PLANNING & ZONING COMMISSION

Regular Meeting Agenda
CITY OF PARKVILLE, MISSOURI
Tuesday, March 10, 2026 5:30 PM
City Hall Board Room

- Agenda Item: 6.A
- Proposal: Application for Final Development Plan for Heaterz, a proposed drive-thru restaurant at 7100 Elizabeth St.
- Staff Recommendation: Approval (with conditions)

- Case No: PZ26-03
- Applicant: Michael Letzig, Heaterz KC LLC
- Owners: City of Parkville
- Location: 7100 Elizabeth St, generally located south of Connections Bank in Old Town at Creekside.

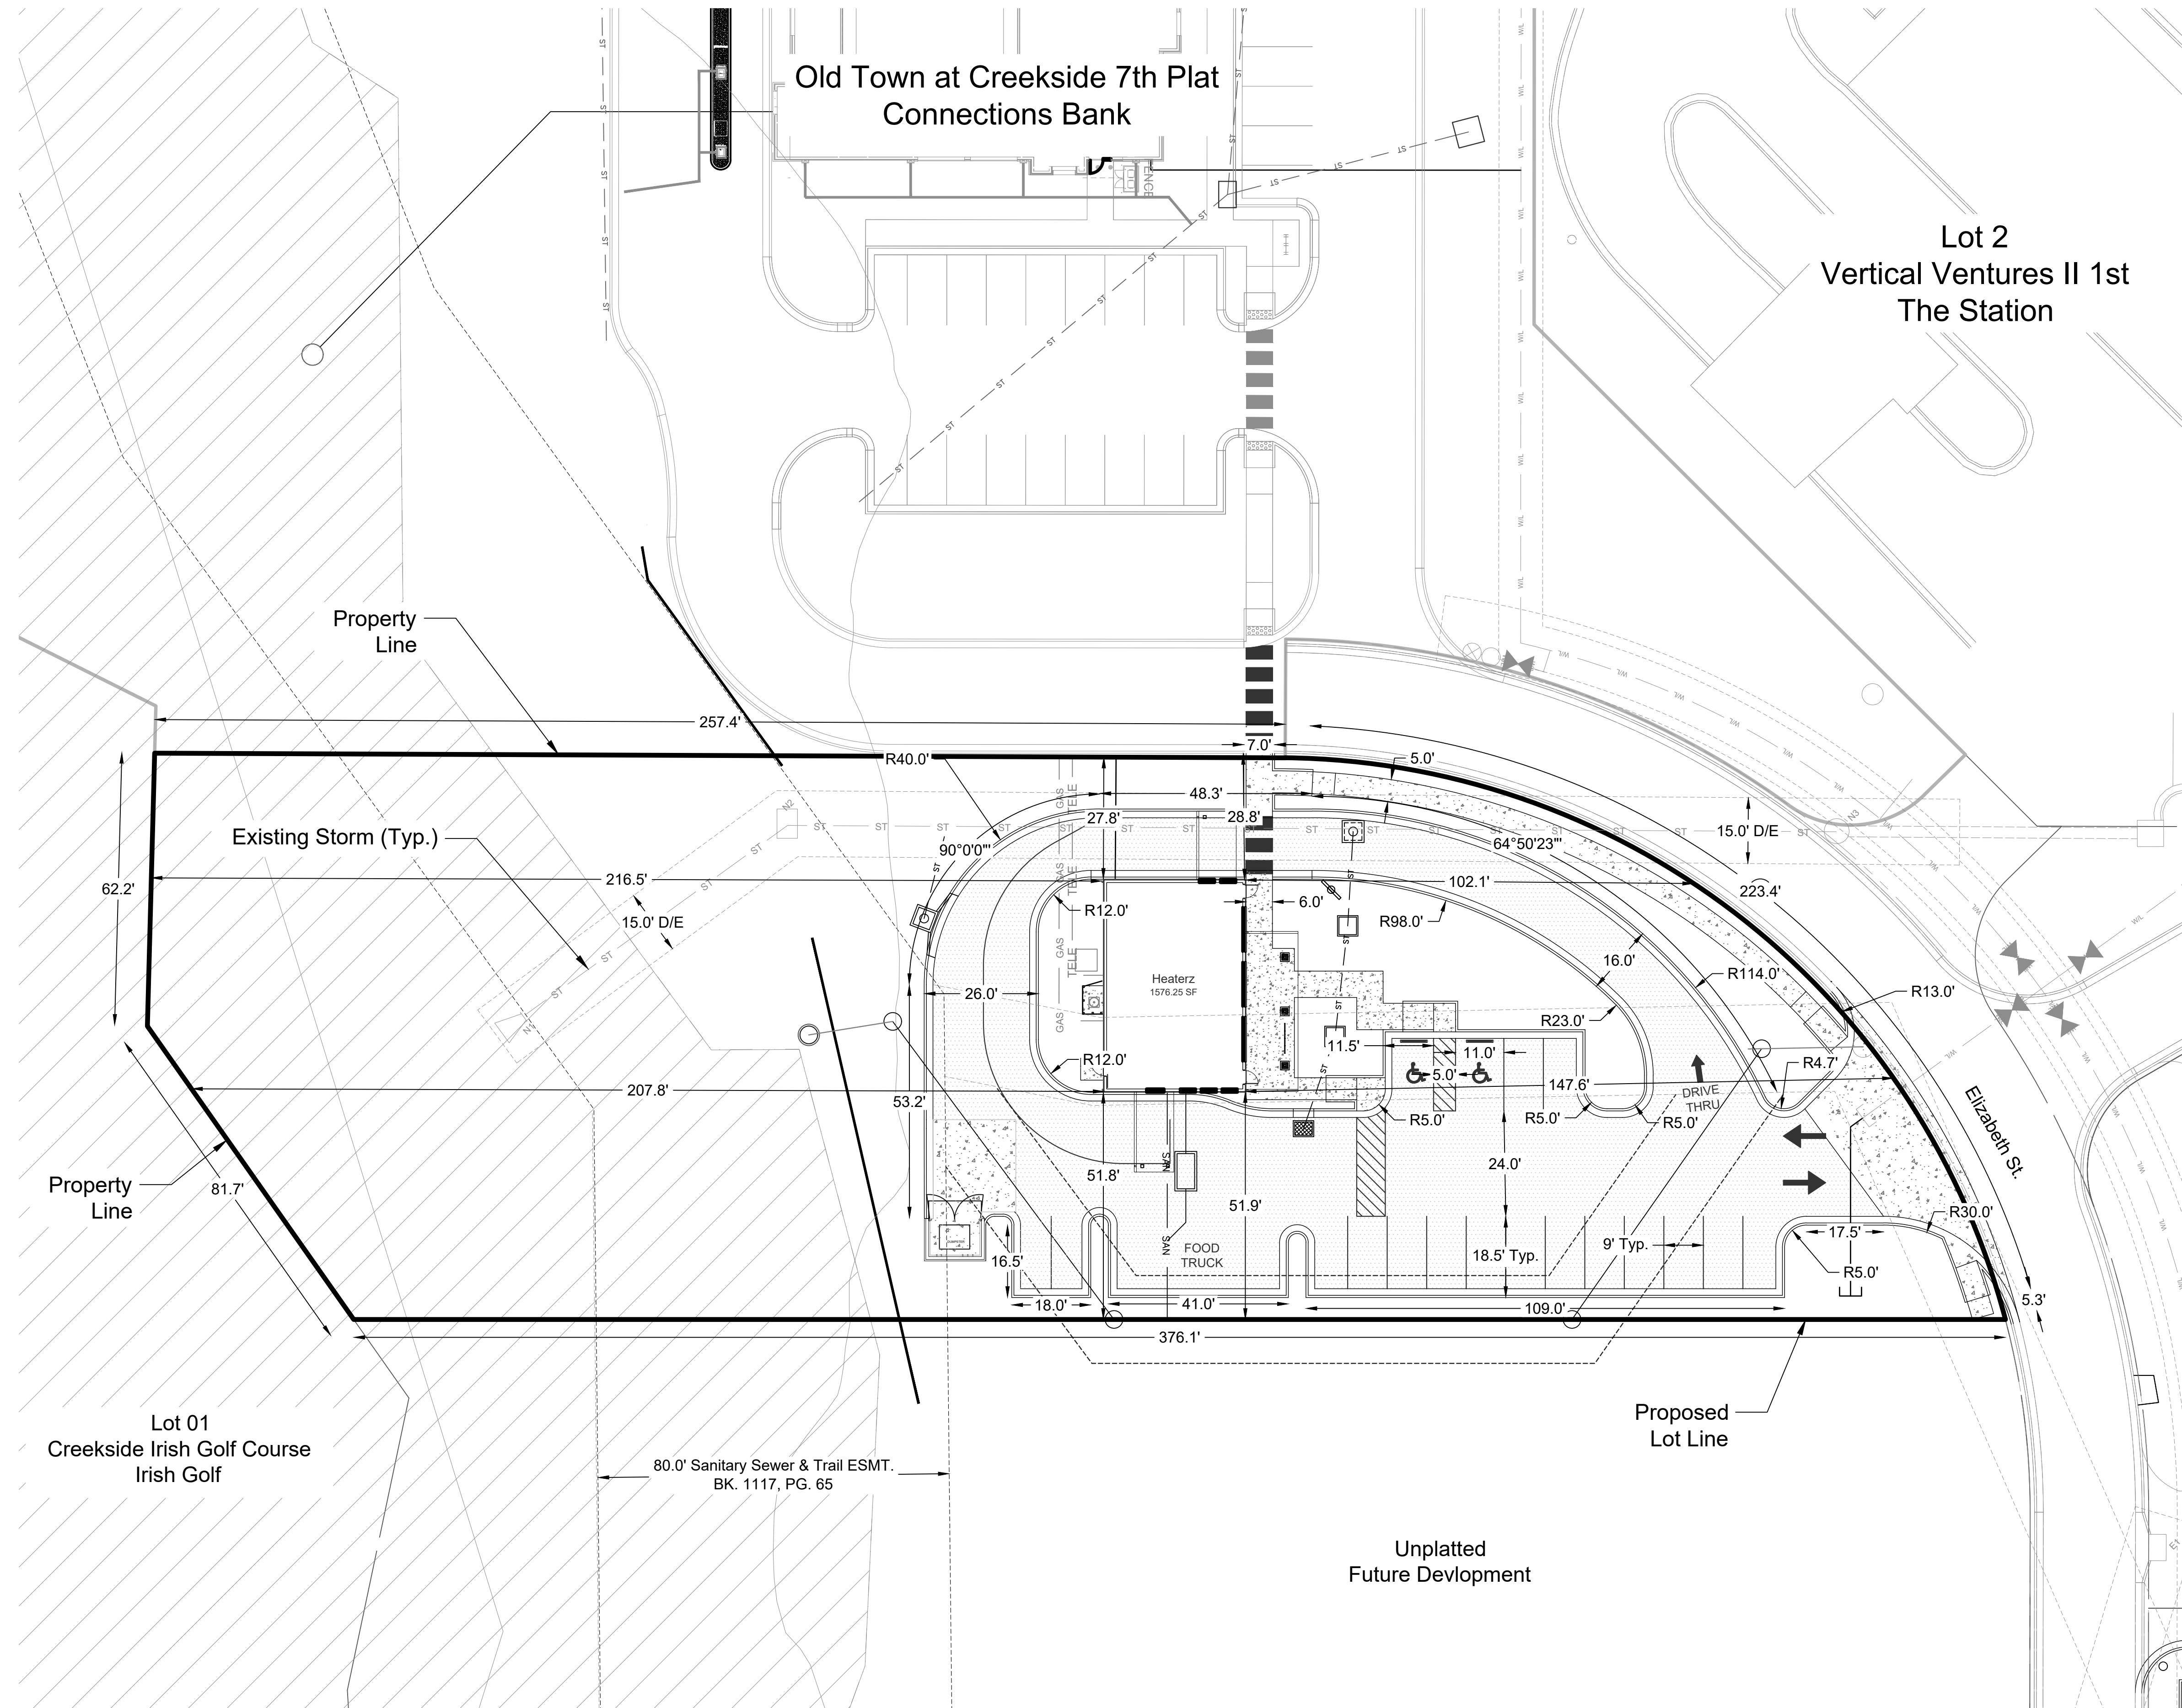
The parking stall dimensions detailed on the site plan (see Exhibit D.2) of 18 ft. length by 9 ft. width do not meet the dimension specifications in Table 408-10: Parking Dimensions. The parking lot aisle width along the west side of the building for the 90° parking angle is 24 ft. which does not meet the required 25 ft. **The applicant may request flexibility from these standards through the Final Development Plan process.**

Landscape Plan

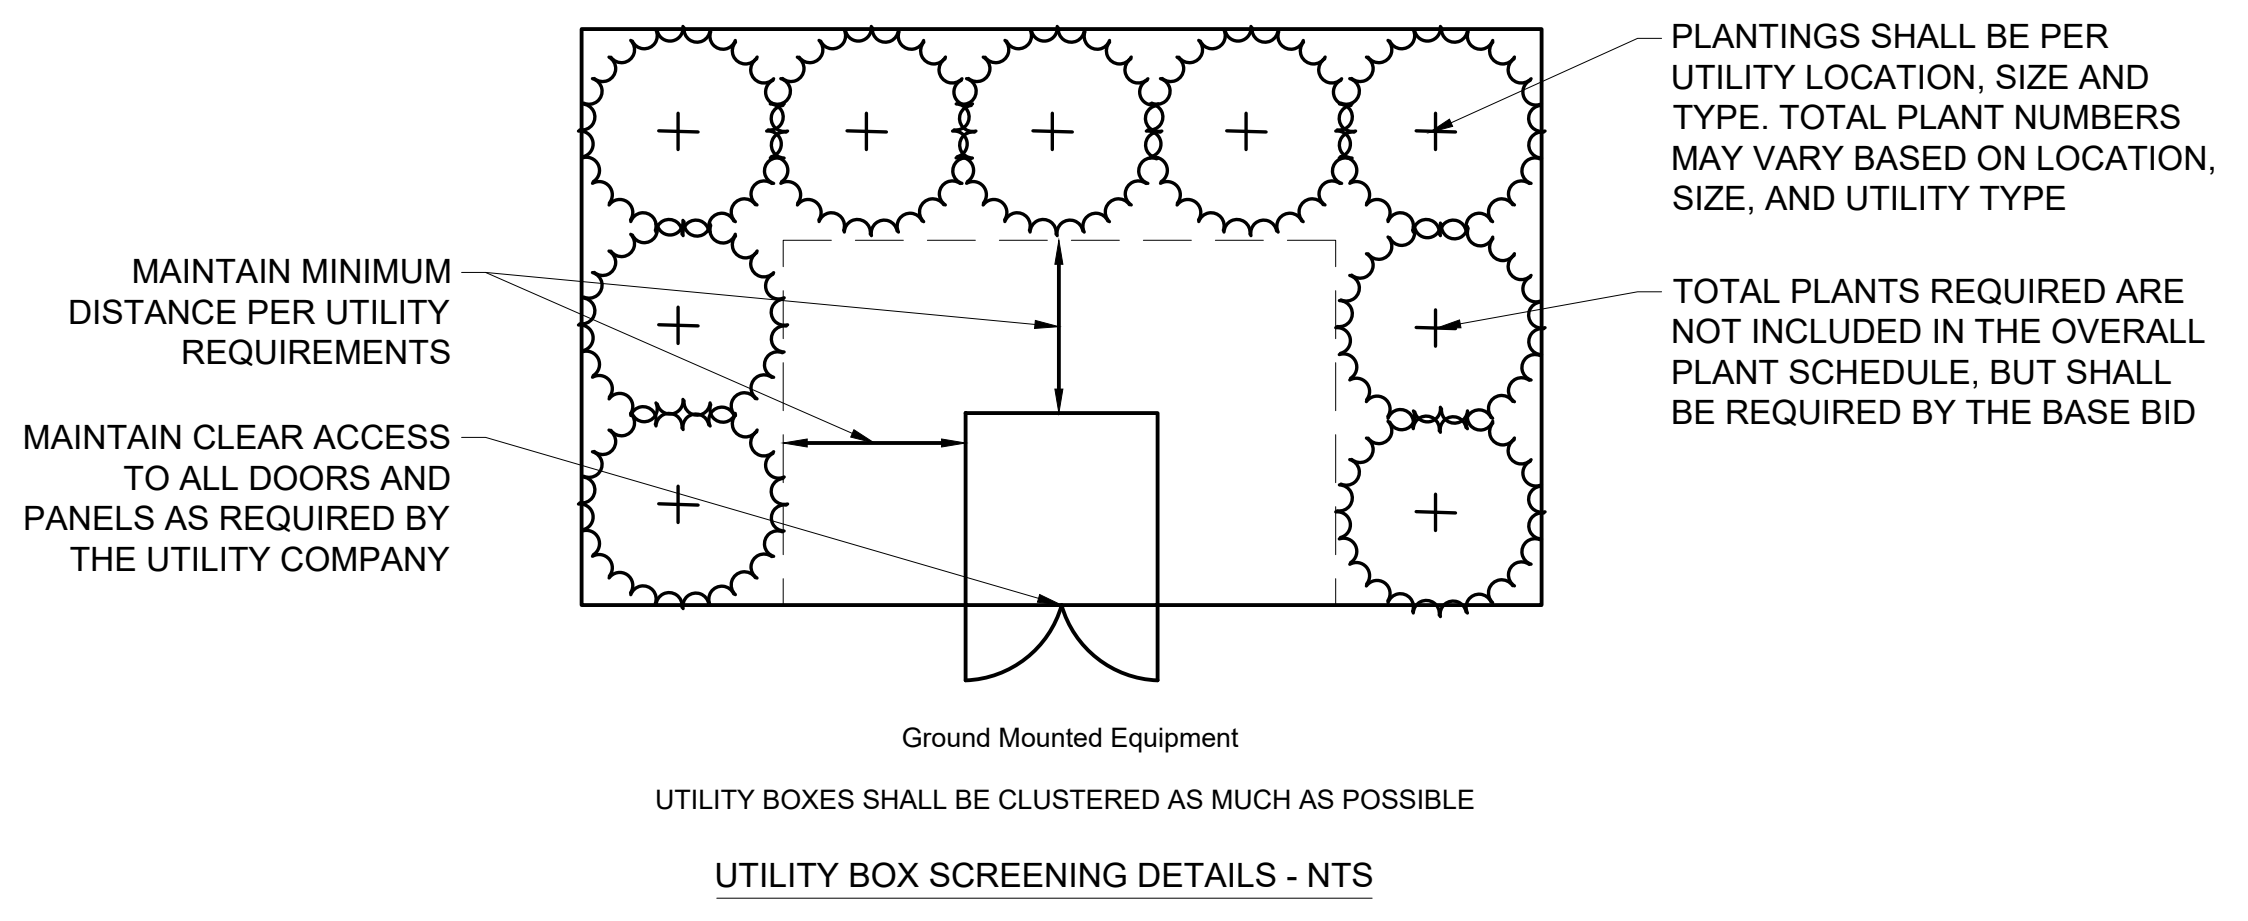
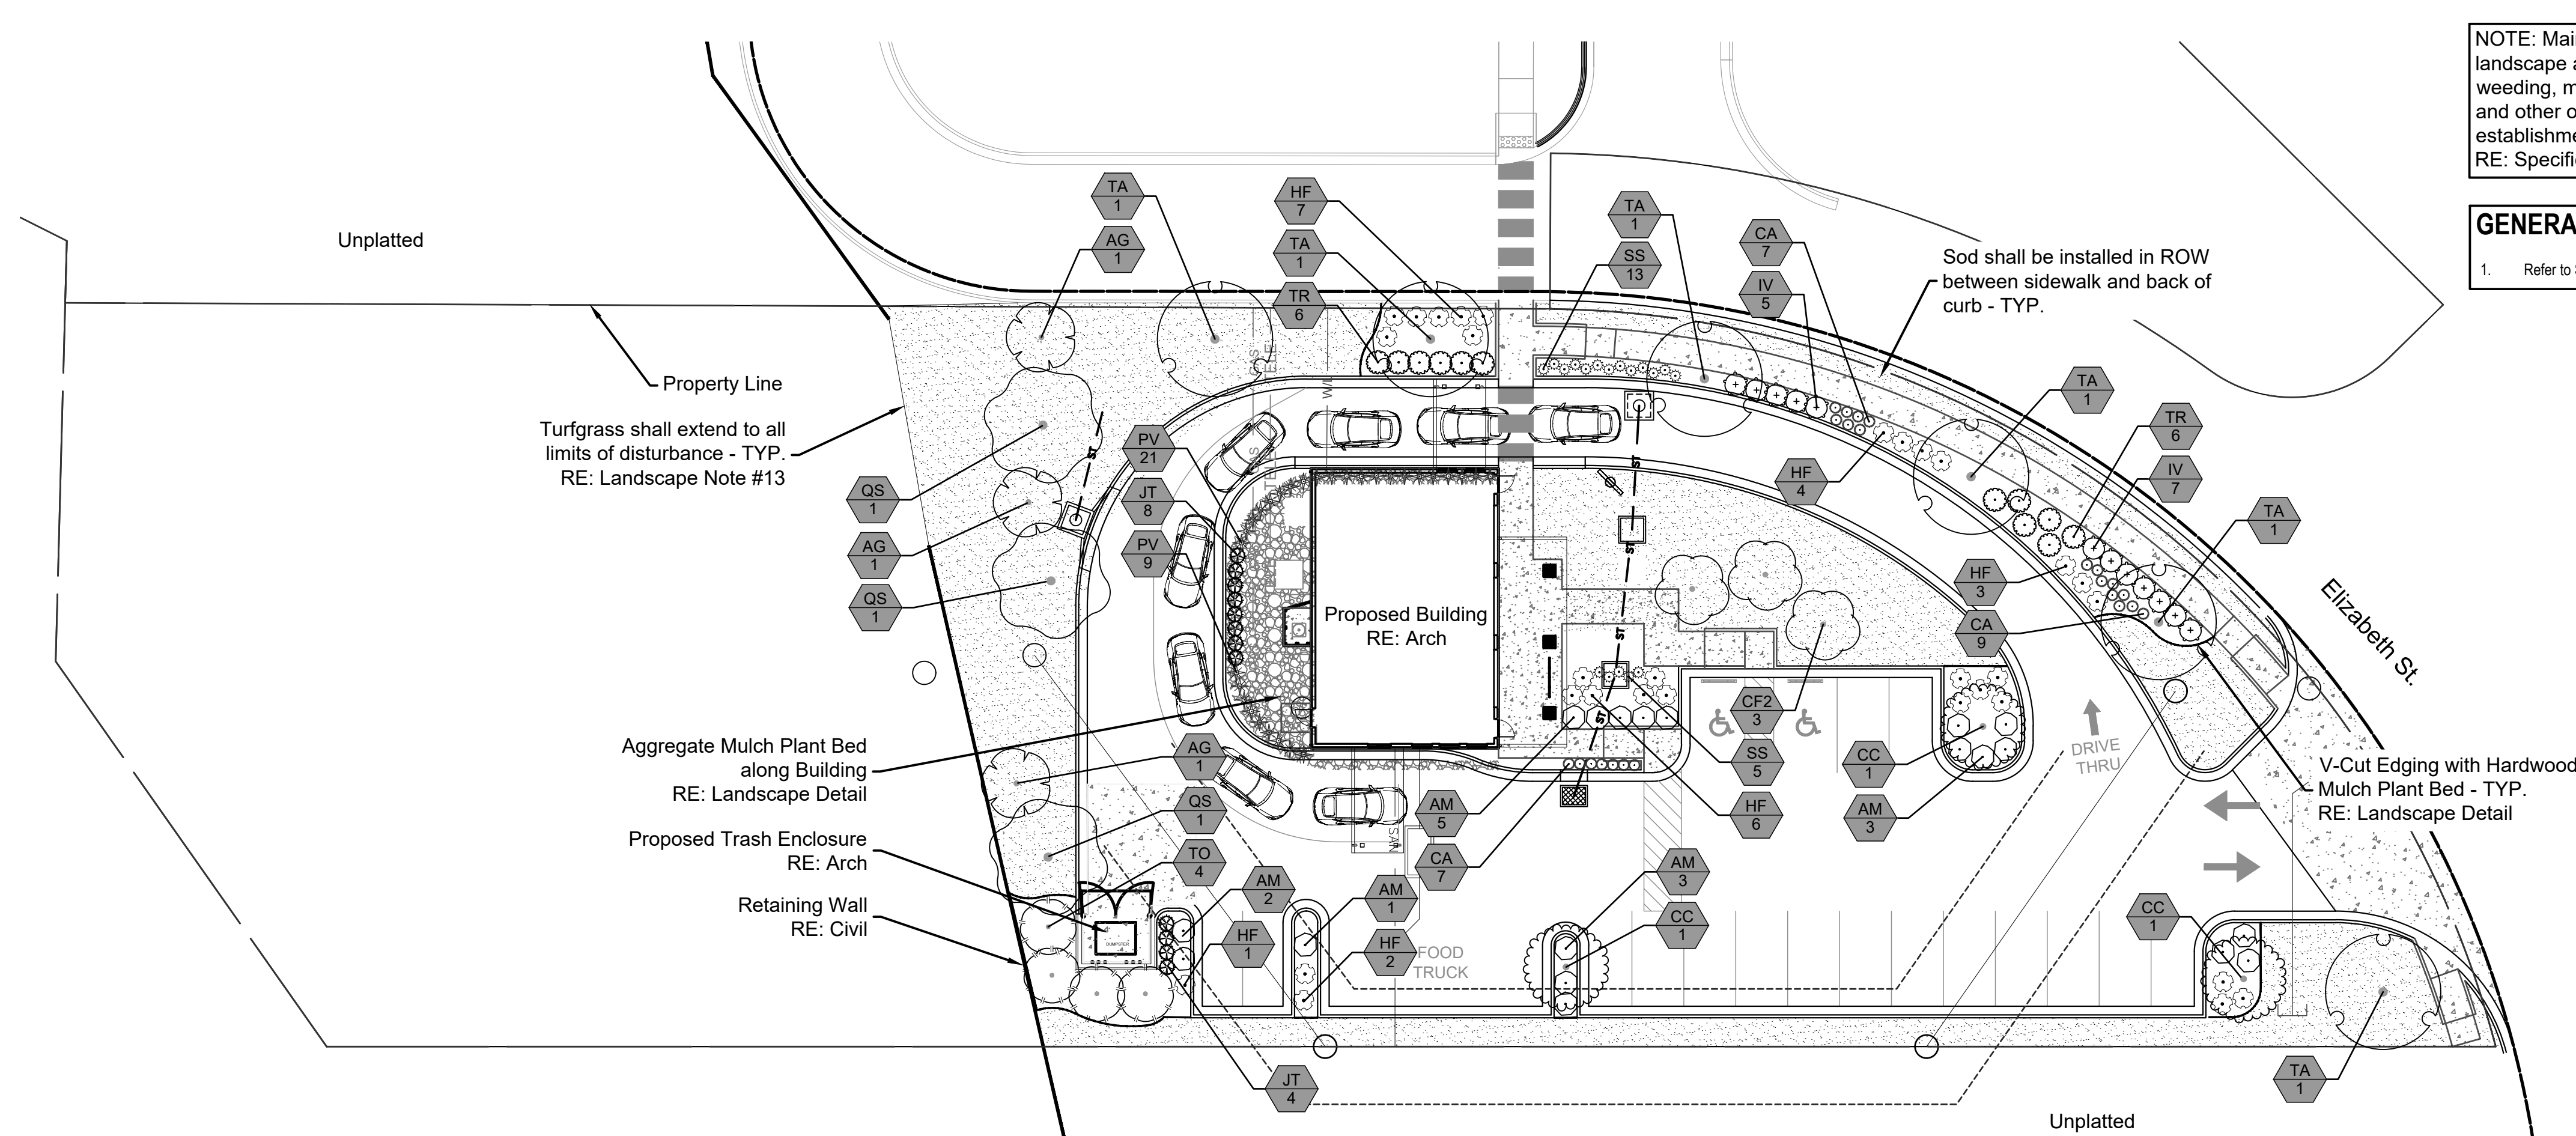
Detailed landscaping plans have been provided (see Exhibit D.6) and meet the City’s landscape design requirements per Section 407.020, including street tree, foundation planting, parking lot planting, buffer and open space requirements. The proposed plant species do not meet our Section 407.020(F) native species requirements. **Prior to Building Permit issuance, the applicant shall submit a revised Landscaping Plan demonstrating compliance with Municipal Code Section 407.020.**

4. Prior to Building Permit issuance, the applicant shall submit a Photometric Plan demonstrating compliance with Municipal Code Section 407.040.
 5. Prior to Building Permit issuance, the applicant shall submit a revised Landscaping Plan demonstrating compliance with Municipal Code Section 407.020.
